The Church Lane Group represents residents that live in close proximity to this proposed solar scheme. We have done our best to reach a compromise with the applicant about its scheme. In the very early days, there were signs that our endeavours could result in a workable and acceptable solution both in terms of design and access arrangements.

We **OBJECT** to this proposal

Church Lane Group

1st March 2024

Mitigating Visual Impact (22/00668/AS)

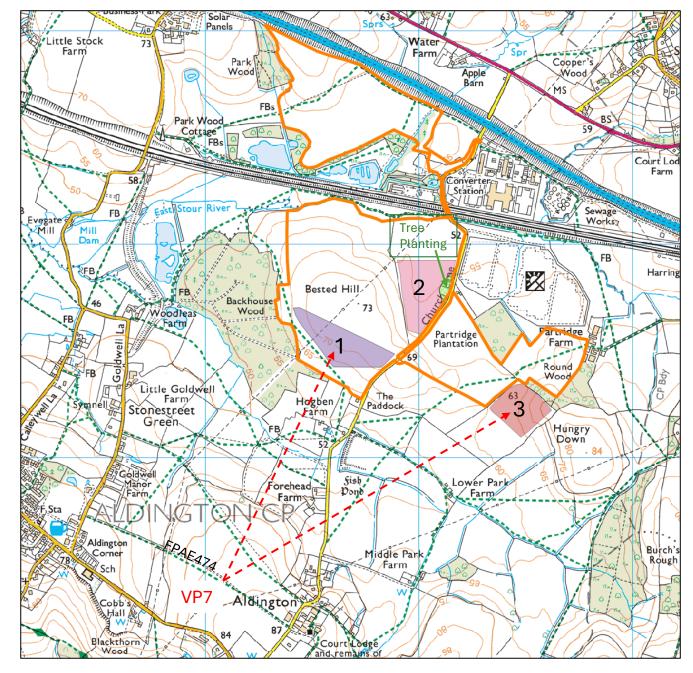
- 6. Instead of doggedly pursuing the application on the basis of including this sensitive area on the southern slope on Bested Hill (which comprises approximately 15 acres of solar array footprint) EDF could relocate this element to the triangular field opposite Bested House. The acreage of the two areas is identical.

- 7. This triangular field (marked as Field 2 on the second attachment "Mitigating Visual Impact") is of poor agricultural quality (something which we know the landowner can confirm), forms a natural shallow bowl in the landscape and will (once boundary hedging has been improved by further planting) be an area of the proposed scheme which will be very difficult to see from any vantage point (much like the existing Partridge Farm solar scheme on the other side of the lane).

- 8. Relocating this small part of the solar array (Field 1 on the same attachment) to this field need not have an unacceptable impact on Bested House. On the contrary, (as shown on the attachment) a swathe of land on the other side of the lane from the house can be planted up with trees (complementing the proposed new hedge planting) to protect views from the house to the west (without any significant shading of panels). In the context of those views, it should be noted that the existing views from the house westwards across the lane are towards the National Grid pylon line and its towers that run across the skyline in full view only 350 metres away.
